Attachment A

Proposed Technical Specification Changes

Reference is made to Pilgrim Nuclear Power Station, Technical Specifications Sections 6.1 thru 6.8 and, Figures 6.2.1 and 6.2.2. The following changes are requested to be made:

Figure 6.2.2

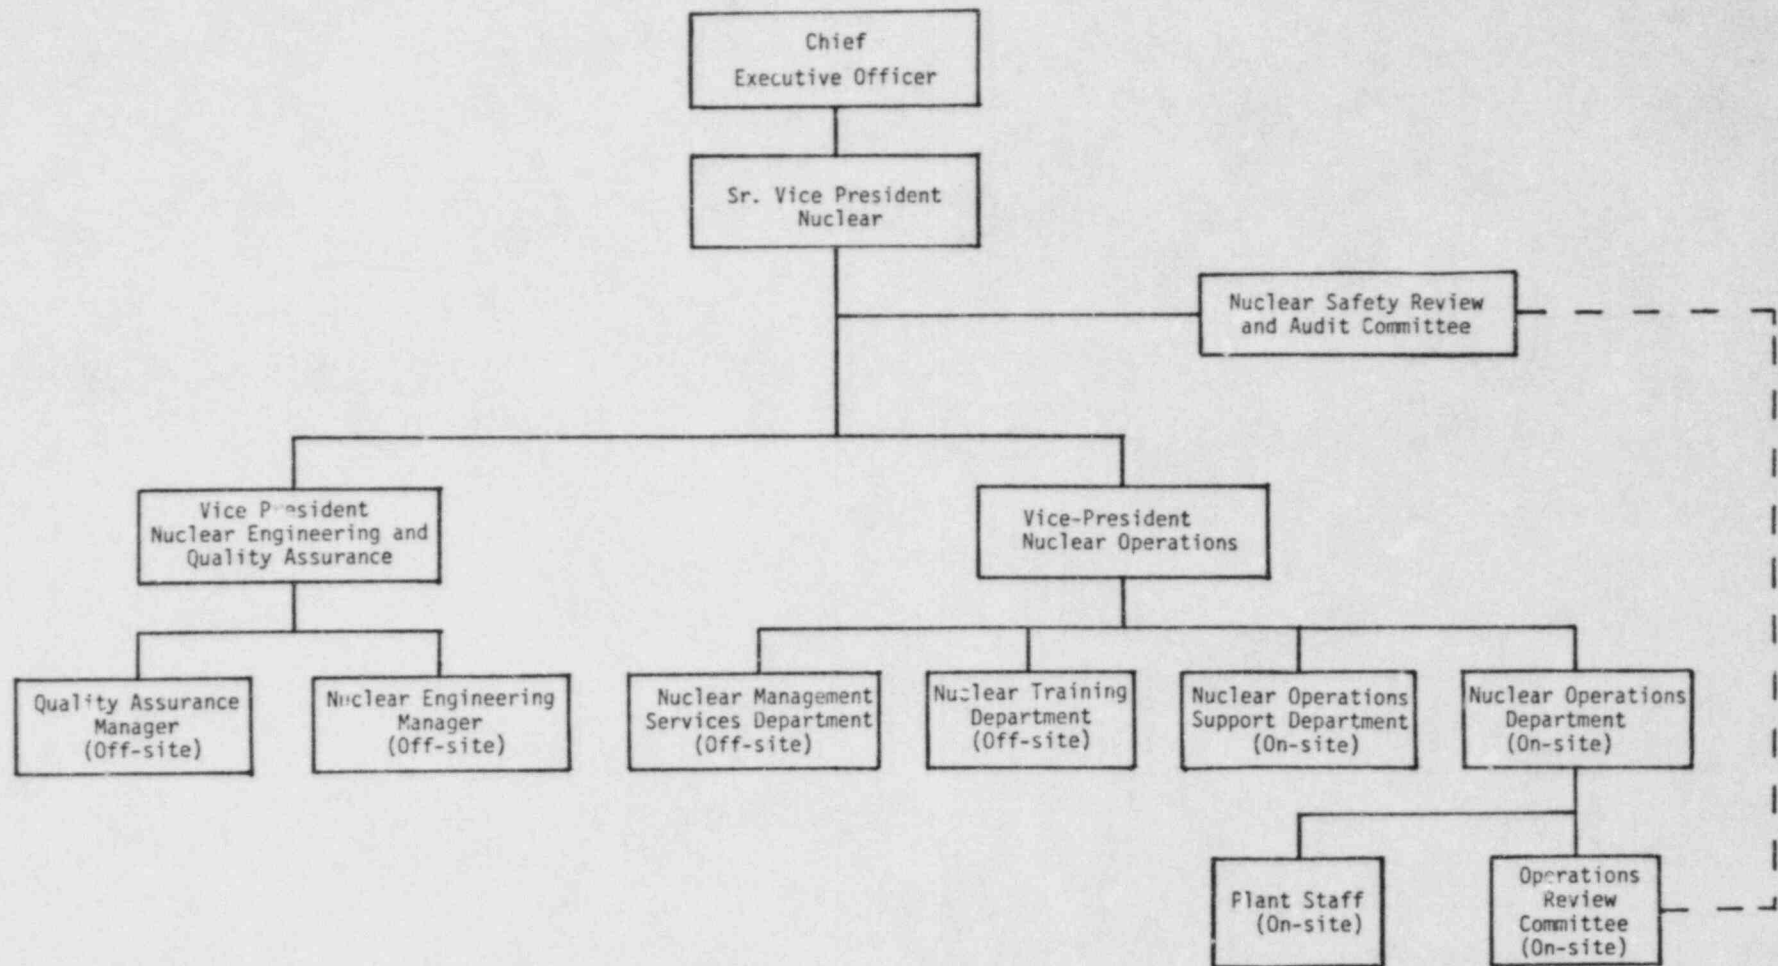
The proposed changes revise most parts of Section 6 and Figures 6.2.1 and 6.2.2 of the Administrative Technical Specifications for Pilgrim Nuclear Power Station. The changes are all administrative in nature and have no safety significance, do not physically affect plant safety related systems, and do not reduce any safety margin. Therefore, the changes do not present an unreviewed safety question as defined in 10CFR50.52(c).
